DEVELOPMENT NO.:	21027668
APPLICANT:	Planning Studio Pty Ltd Vinteloper Wines
ADDRESS:	589 CUDLEE CREEK RD CUDLEE CREEK SA 5232 CT 5946/767
NATURE OF DEVELOPMENT:	Convert former dwelling to shop for the sale and tasting of wine with associated building alterations & additions, associated car-parking and landscaping
ZONING INFORMATION:	<p>Zones:</p> <ul style="list-style-type: none"> • Productive Rural Landscape <p>Overlays:</p> <ul style="list-style-type: none"> • Environment and Food Production Area • Hazards (Bushfire - High Risk) • Hazards (Flooding - Evidence Required) • Limited Land Division • Mount Lofty Ranges Water Supply Catchment (Area 2) • Native Vegetation • Prescribed Water Resources Area • Traffic Generating Development • Urban Transport Routes • Water Resources
LODGEMENT DATE:	28 October 2021
RELEVANT AUTHORITY:	Assessment Panel at Adelaide Hills Council
PLANNING & DESIGN CODE VERSION:	2021.15

PLANNING ASSESSMENT REPORT

Ref: App ID 2102 7668 AHC RFI response

Figure 1: Recommended minor alternation to car park access

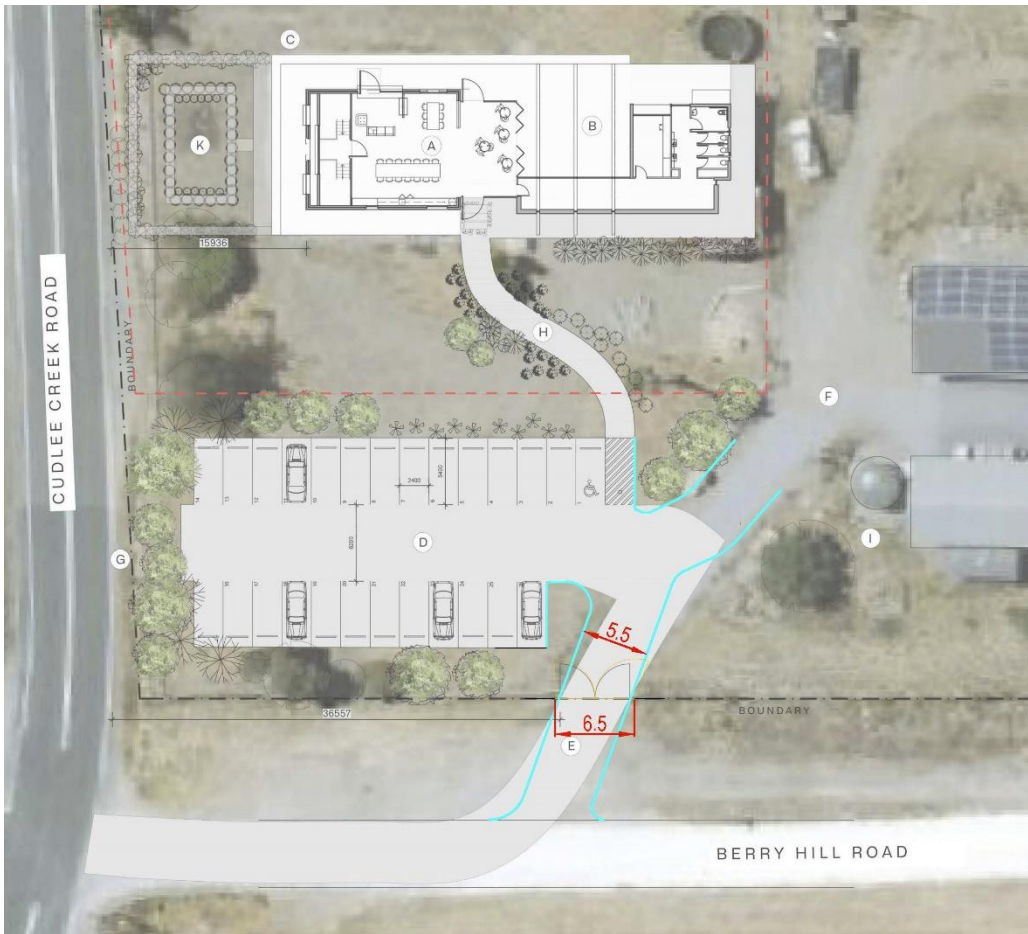
I have also reviewed the proposed access for the site. The current proposal uses an existing driveway and gate to access the site. However, the angle of the driveway does not conform with the recommendations in *Australian/New Zealand Standard Parking Facilities, Part 1 Off-Street Parking (AS/NZS2890.1:2004)* in that the driveway should intersect with the road at an angle of no greater than 70°. Further, it would be desirable for the driveway to be at least 5.5m in width to accommodate two-way traffic movements to and from the car park (the balance of the driveway can remain at the existing width). Figure 1 illustrates a minor recommended modification to the access design.

The Traffic Engineer from MFY recommended that the existing access point and internal driveway be slightly modified to comply with the relevant Australian Standard Off-Street Parking (AS/NZS2890.1:2004). Recommended condition four (4) requires the provision of an amended car-parking plan demonstrating compliance with AS/NZS2890.1:2004 prior to Building Consent. This condition also requires the car-parking to be completed prior to the shop use commencing.

In summary, while the proposal for the cellar door will generate additional traffic volumes, such volumes will be low and will not change the nature or function of the road or the existing intersection. Minor changes to the car park access design will be beneficial to achieve compliance with AS/NZS2890.1:2004.
